## Post-Construction Stormwater Management Applicability Evaluation Form

| Part I. Project Information  |   |
|--|---|
| 1. Project Name: CSU Marksheffel Connector   |   |
| 2. El Paso County Project #: <b>CDR245</b>   | 3. ESQCP #: <del>DOT2021-04</del>               |

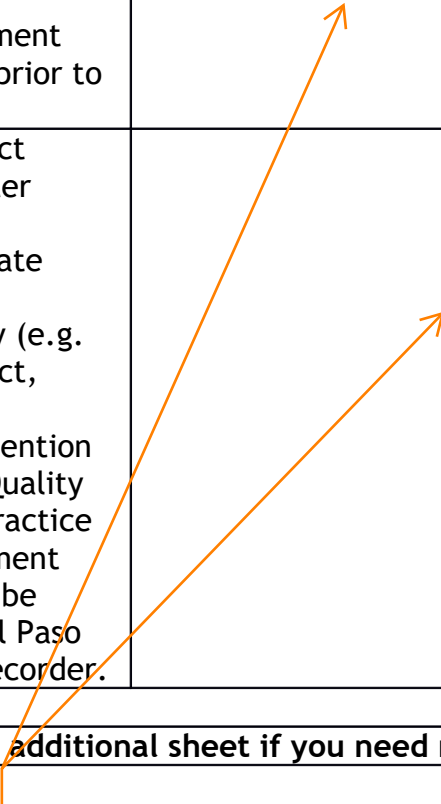
This applies to roadway projects, not utility project. The entire project seems to be a linear utility project and as such would be covered fully under Exclusion D.
